Reply on RC1

Author comment on "Performance of the Adriatic Sea and Coast (AdriSC) climate component – a COAWST V3.3-based coupled atmosphere–ocean modelling suite: atmospheric dataset" by Cléa Denamiel et al., Geosci. Model Dev. Discuss., <https://doi.org/10.5194/gmd-2021-3-AC1>, 2021

Figure R1. Seasonal variations of the median hourly temperature bias between AdriSC WRF 3-km model results and NOAA land station measurements during winter (DJF), spring (MAM), summer (JJA) and autumn (SON) for the 1987-2017 period.

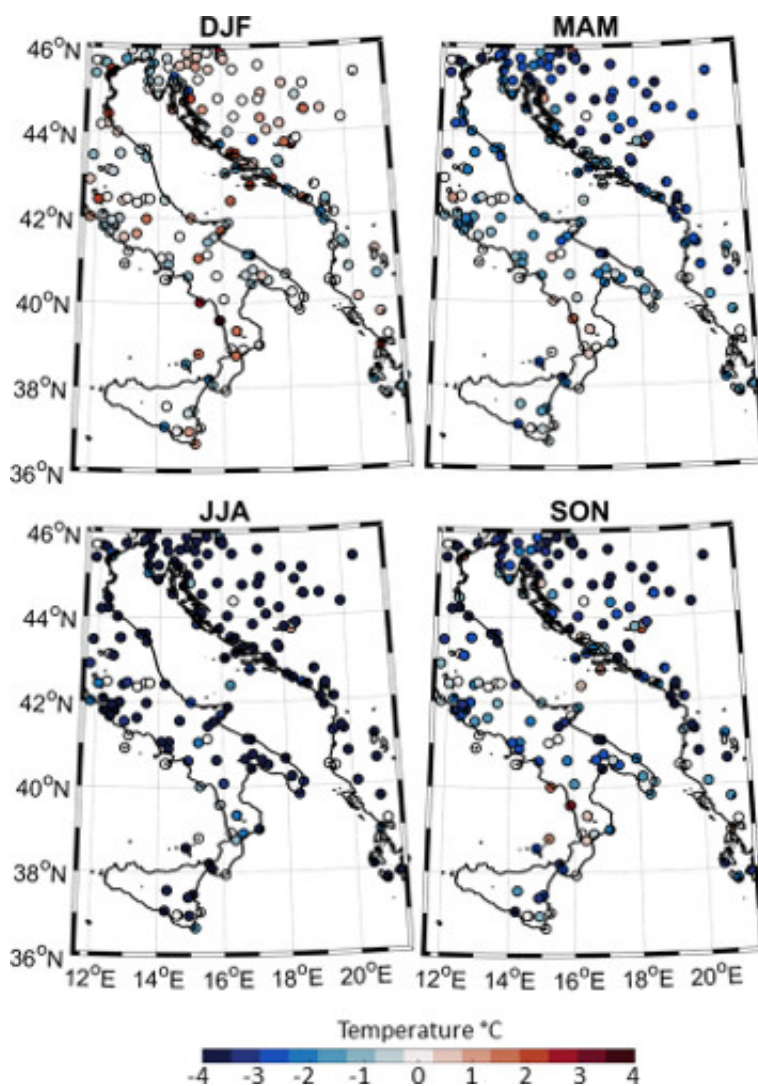
Fig.12 -Fig.15 I would color both land and sea in white and leaves in black only the coastlines: the marker line of each dot can be also done in black

Response: The suggestion of the reviewer was implemented in Figure R1 (see below) for the 2 m air temperature, as an example. The authors believe that the obtained figure looks extremely empty and is overall more difficult to read due to a lack of contrast which is not present in the original figures. Consequently, the authors will keep Fig. 12 to 15 as presented in the original version of the article.

Figure R2. EOF analysis (three first components) of the sea-surface height extracted from MEDSEA for the 1987-2017 period.

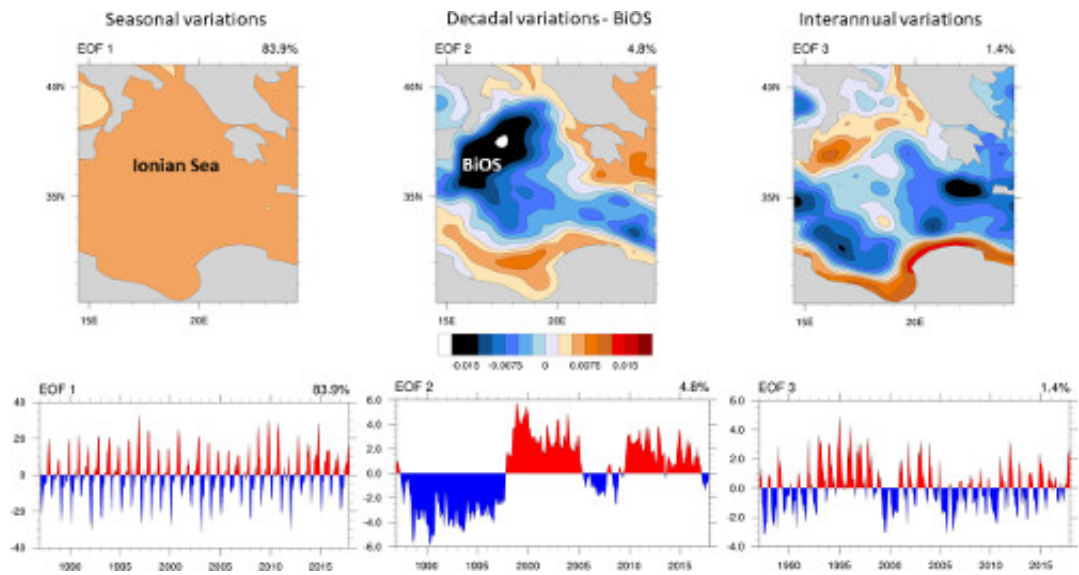
Line 558-560 (and after) I would be a little bit careful with that. As far as I remember Theocharis et al., 2014, Reale et al., 2016 and Reale et al., 2017 discussed the necessity of the inclusion of the Aegean Sea in the Adriatic Ionian to explain the BIOS variability...I should discuss that in the sentence. Moreover, does it mean that you plan to include also the Aegean Sea in your modeling domain? Do you expect that the MEDSEA (which provide the BCs in the ocean model) reanalysis include the BIOS signal? Did you check that?

Response: Yes, the authors have checked that the BiOS is reproduced by the MEDSEA re-analysis. Gačić et al. (2011) have demonstrated that the BiOS is well described with the decadal change of sign of one of the main components of the EOF derived from sea-surface height. Figure R2 (see below) is indeed showing the EOF analysis (3 first components) of the sea-surface height extracted for 1987-2017 period within the Ionian Sea. The BiOS is also seen by the ROMS 3-km ocean model used in the AdriSC climate model and the results will be soon submitted by Pranić et al. (2021) to GMD. However, the authors would agree with the reviewer that the BiOS is located a bit too close to the southern open boundary of the AdriSC WRF/ROMS 3-km grids and will be influenced by the MEDSEA forcing in the AdriSC climate model. Nevertheless, the authors also believe that they can still use the 31-year AdriSC 3-km results to look at the drivers of the BiOS particularly to confirm whether this driver is the dense water coming from the Adriatic Sea. The sentence will be reformulated as follow:

"Additionally, as the MEDSEA re-analysis captures the BiOS signal within the Ionian Sea (e.g. Pinardi et al., 2015), the inclusion of the Aegean Sea suggested by Reale et al. (2017) is not necessary if MEDSEA is used as a forcing. Consequently, the AdriSC climate model has also been developed with the aim to expand the knowledge on whether the Adriatic dense waters travelling towards the Ionian Sea can be an important driver of the BiOS."
